UNITED STATES PATENT AND TRADEMARK OFFICE

APPLICATION NO.	FILING DATE	FIRST NAMED INVENTOR	ATTORNEY DOCKET NO.	CONFIRMATION NO.
10/088,575	05/10/2002	Michel Bremont	RAG-14302/08	4825
25006	7590	03/07/2005	EXAMINER	
GIFFORD, KRASS, GROH, SPRINKLE & CITKOWSKI, P.C PO BOX 7021 TROY, MI 48007-7021			MAKI, STEVEN D	
			ART UNIT	PAPER NUMBER
			1733	
DATE MAILED: 03/07/2005

Office Action Summary

Two enlarged partial copies of Figure 4 of Nakashiba et al is reproduced below:

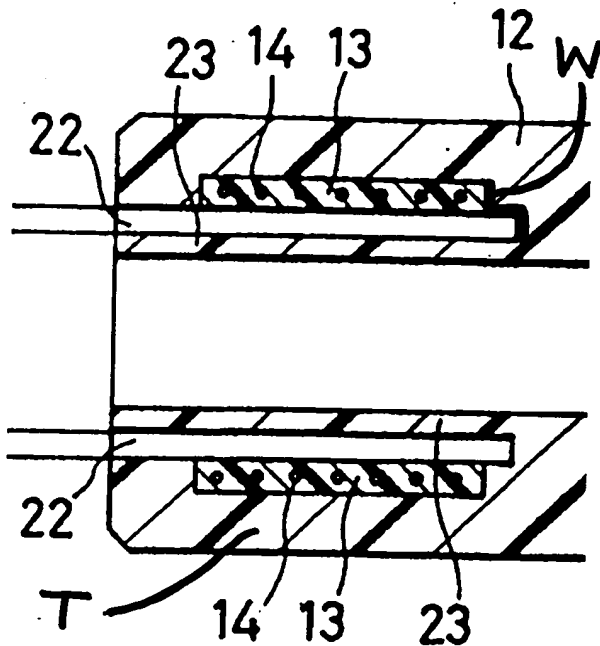
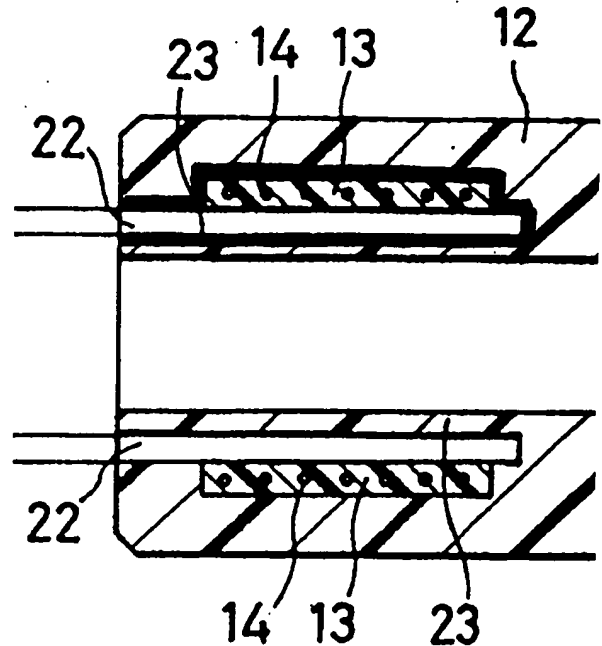
In figure A, the reference letters W and T in the above figure A were added by the examiner. The reference letter T indicates the "outer tube". The reference letter W indicates the "connecting wall". The surface of the "connecting wall" W has been darkened by the examiner in the above enlargement of figure 4 to facilitate discussion of figure 4. In figure B, the darkened lines (bold face lines) indicate the inner surface of the "annular gap".

With respect to the "connecting wall", the surface of the connecting wall W interconnects the rear end of the "outer tube" T and the rear end of the "inner tube" 23.

The claimed connecting wall reads on this "connecting wall" of Nakashiba et al. It is acknowledged that the surface of "connecting wall" in figure 4 of Nakashiba et al comprises two vertical sections connected together by a horizontal section. However, the claimed connecting wall reads on a connecting wall having, in cross section along the axis of the tubes, a non-linear (stepped) surface facing the annular gap. In other words, the claimed tubular coupling element fails to require a connecting wall defining a *flat* surface, which extends *linearly* from an inner cylindrical surface of the outer tube to an outer cylindrical surface of the inner tube. Claims 7-13 fail to specify the *shape* of the rear end of the outer tube, the *shape* of the rear end of the inner tube and the *shape* of the connecting wall.

Furthermore, "a solid ring of hot melt adhesive insertable into the annular gap and positioned against said connecting wall" (emphasis added) defines *the location of the solid ring* in the tubular coupling element, but fails to require a *process step* of making the tubular coupling element by *inserting* the solid ring in a preexisting annular gap. See MPEP 2113. The claimed solid ring reads on Nakashiba et al's solid ring 13, which (1) is in an *inserted* position within the annular gap defined by "the outer tube", "connecting wall" and "inner tube" and (2) is *positioned* against the surface W of the "connecting wall". With respect to "hot-melt", the claimed solid ring of hot-melt adhesive reads on the solid ring of noncrosslinked polyolefin since when the "electrofusion joint" ("tubular coupling element) is used, it melts and fuses to the tubular member. See col. 6 lines 41-42.

Applicant argues that Nakashiba et al does not disclose a connecting wall secured to the rear end of an inner tube and a rear end of the concentric outer tube that defines an annular gap. Examiner disagrees since Nakashiba et al's figure 4 embodiment comprises a connecting wall connected to rear ends as claimed. See above discussion regarding figures A and B. It is emphasized that the neither the *shape* of the rear ends nor the *shape* of the connecting wall is specified in claims 7-13.

Applicant argues that Nakashiba et al's bonding layer (ring 13) is adjacent a groove instead of in an annular gap (page 14 of response filed 10-22-04). This argument is not commensurate in scope with the claims and is therefore not persuasive since claims 7-13 fails to specify the *shape* of the annular gap.
